Design Review Subcommittee (DRSC)

SUBJECT: **Conditional Use Permit Amendment 19-405 and Minor Cultural Heritage Permit 19-411, La Galette CUP Amendment and Exterior Improvements**, a request to amend La Galette's CUP to expand the alcohol service area onto adjacent vacant suites, and to allow exterior improvements, including additional seating on the sidewalk, on the first-level of commercial suites located at 612 Avenida Victoria A-E.

PROPOSED FLOOR PLAN

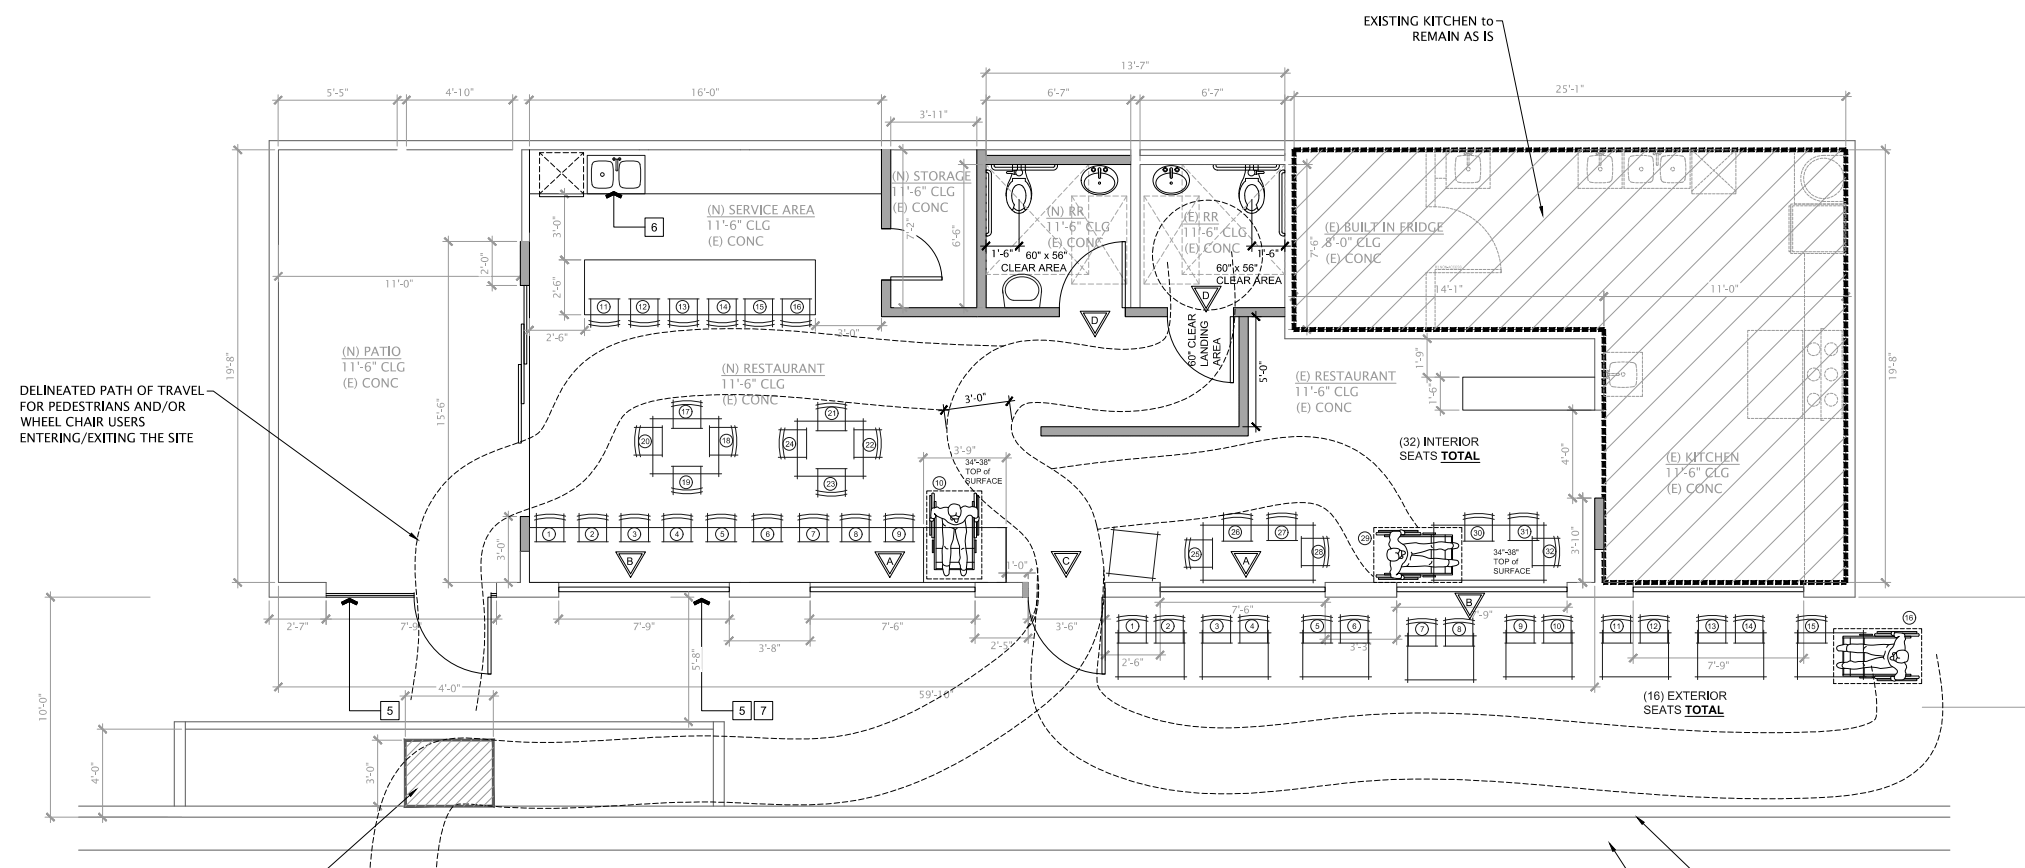
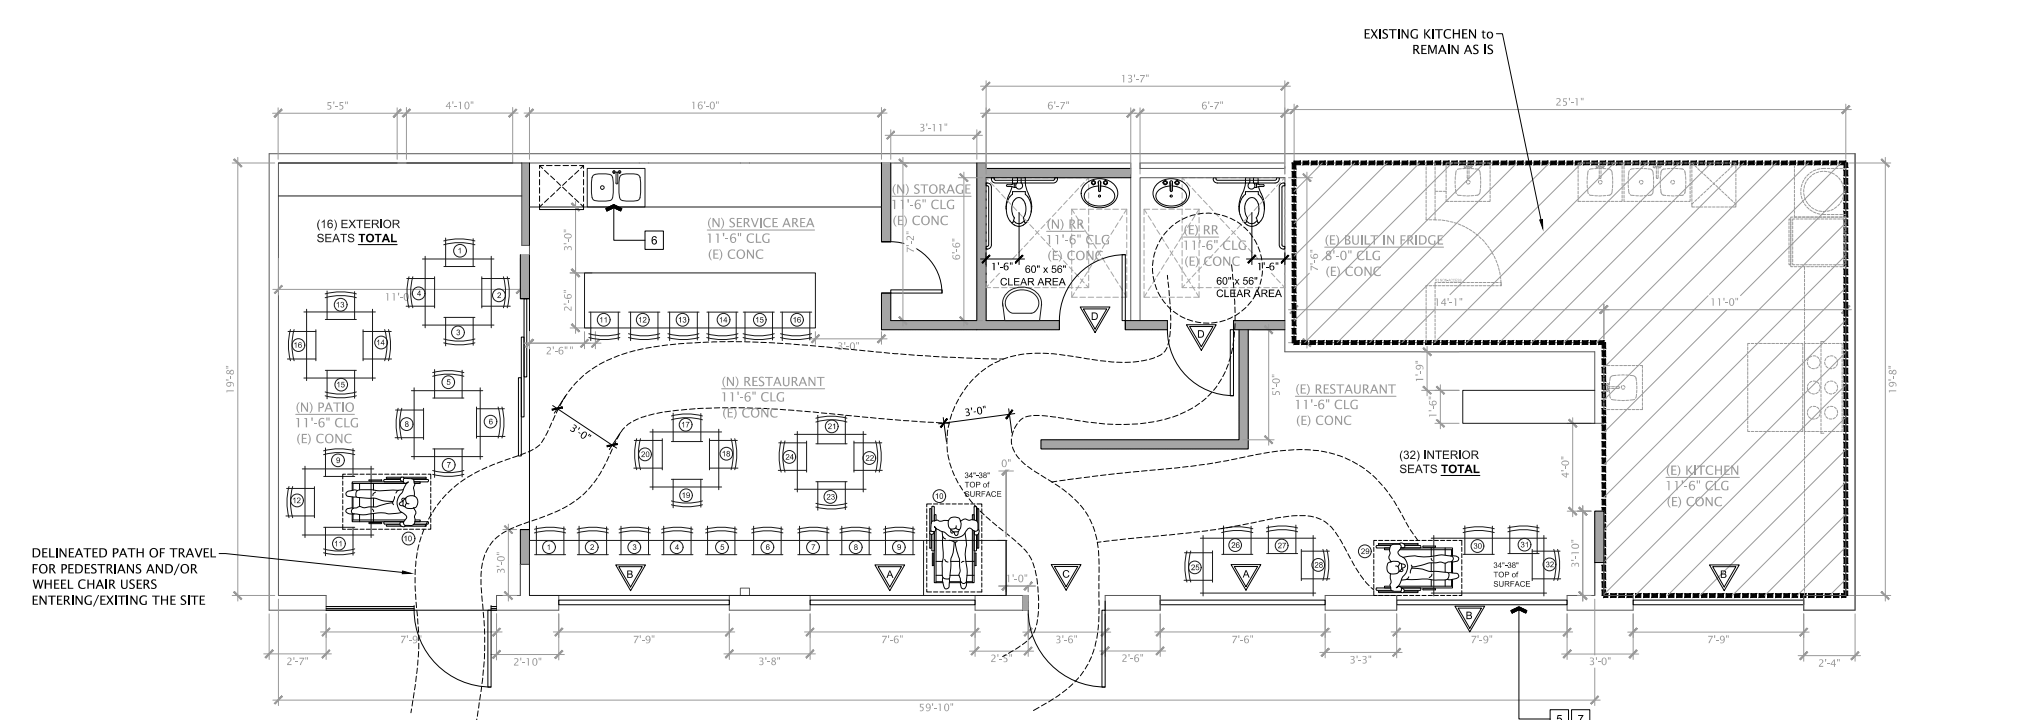
As previously stated, La Galette currently has approval for eight seats and four tables on the sidewalk adjoining the building. The new eight seats and four tables are proposed to match the configuration as the approved outdoor seating, as shown on Sheet A3.1 of conceptual plans (Attachment 4). LUP and General Plan Policies, and Pedestrian Overlay District Goals support visitor-serving uses and outdoor dining in this area. The current outdoor seating was approved to use a five-foot wide section from the building, leaving five feet of sidewalk. The Bicycle and Pedestrian Master Plan recommends six feet of sidewalk in mixed use areas. However, staff supports the new outdoor seating contingent on clearance by the Building and Engineering Division which ensure a sufficient width is provided. Currently, the applicant must provide revised plans to the Building Division, prior to scheduling the project for a hearing, which show a handicapped outdoor seat, a path of travel from inside the restaurant to the accessible outdoor seat, an adequate maneuvering area for a wheelchair, and width dimensions on the sidewalk. Additionally, the Engineering Division advised the applicant that a condition of approval may be added, which requires that all outdoor seating remain south of the main entrance, due to the handrail and path behind the ADA ramps. Staff recommends that the applicant address all Building Division comments prior to scheduling the project for a public hearing.

EXISTING WEST ELEVATION
SCALE: 1/4" = 1'-0"

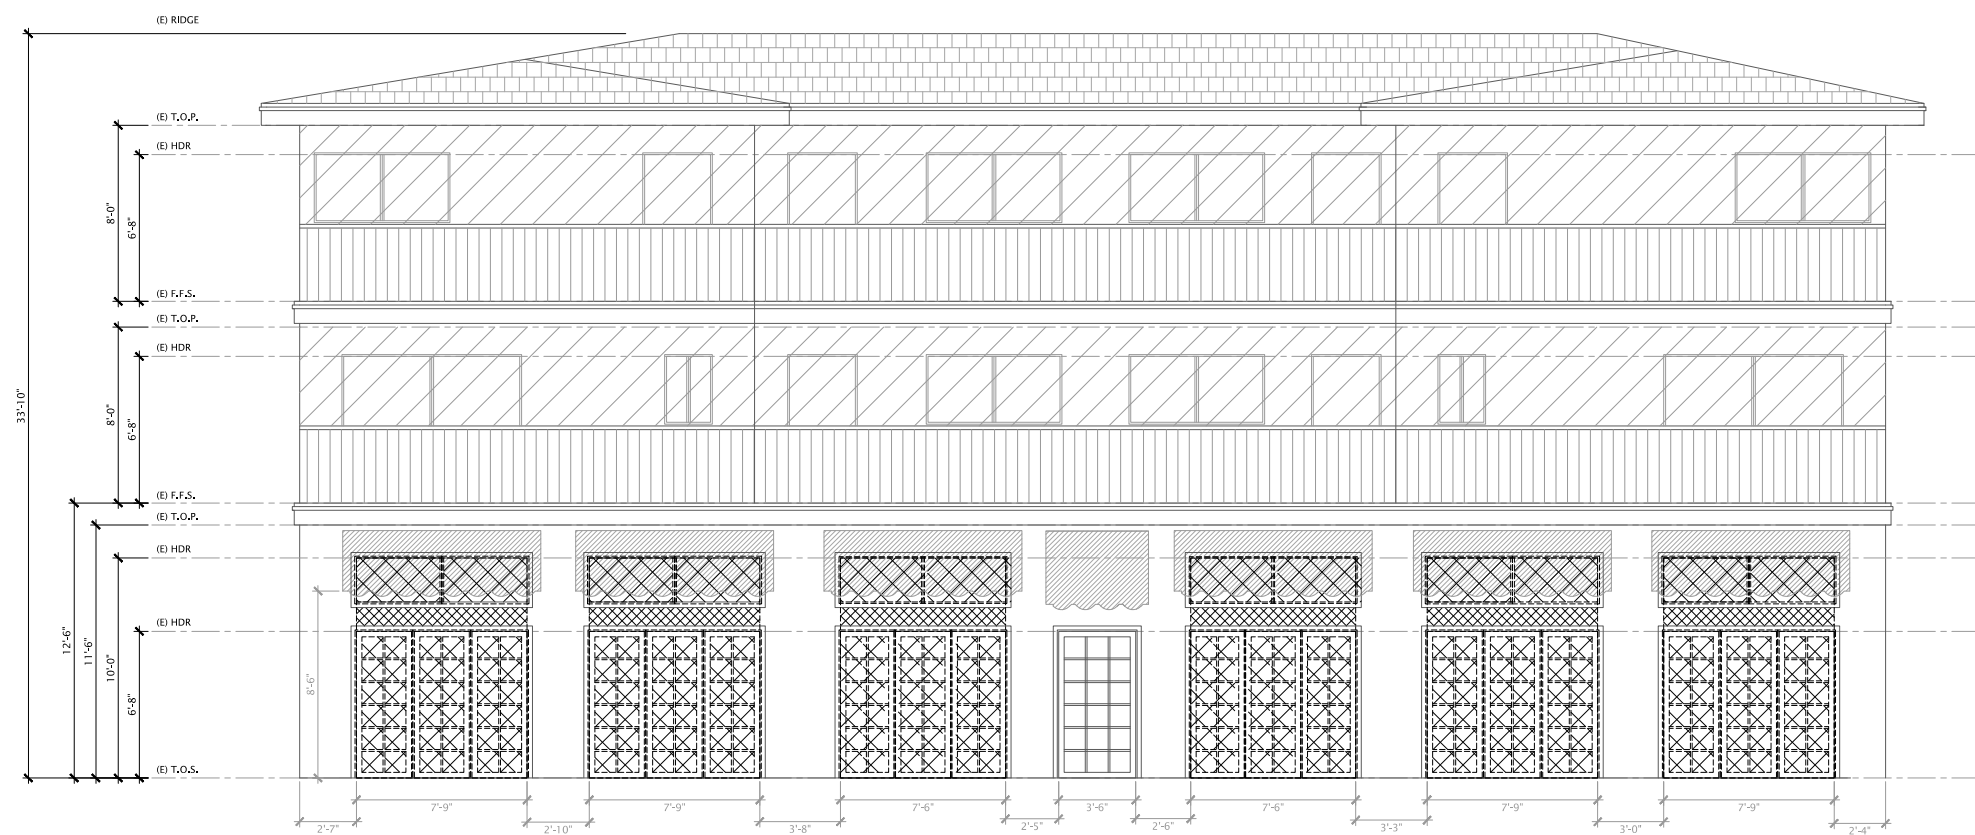
The existing design of the three-panel French doors is in line with the architectural vision and goals for the Pier Bowl, which call for designs that are consistent with Spanish Colonial Revival architecture. The three-panel French doors are appropriately sized at human scale with transom windows above each opening and compatible-sized glass panels that help break up the overall height. The proposed aluminum material and open-feel ambiance that the roll-up doors would provide are consistent with design guidelines, pedestrian-oriented goals, and other restaurants in Downtown (Nick's and Brussels Bistro). Additionally, the use of the aluminum roll-up door frame with the metal mesh to secure the new patio, is a compatible and decorative alternative to a standard metal security gate typically used to secure outdoor spaces. However, the design and height of the proposed roll-up doors present an industrial-like appearance incompatible with the current human scale provided by the existing French doors and transom windows. Therefore, staff recommends that the applicant explore ways to break up the height of the proposed openings, and incorporate smaller glass panels, closer to the existing design of

the French doors and transom windows. Staff recommends using the top of the central main entry door as a horizontal reference line across the façade to guide a breaking point and achieve an appropriate scale, as shown on Image 3 below.

1. Explore ways to break up the height of the proposed openings, and incorporate smaller glass panels, closer to the existing design of the French doors and transom windows.
2. Address all Building Division comments prior to scheduling the project for a public hearing.
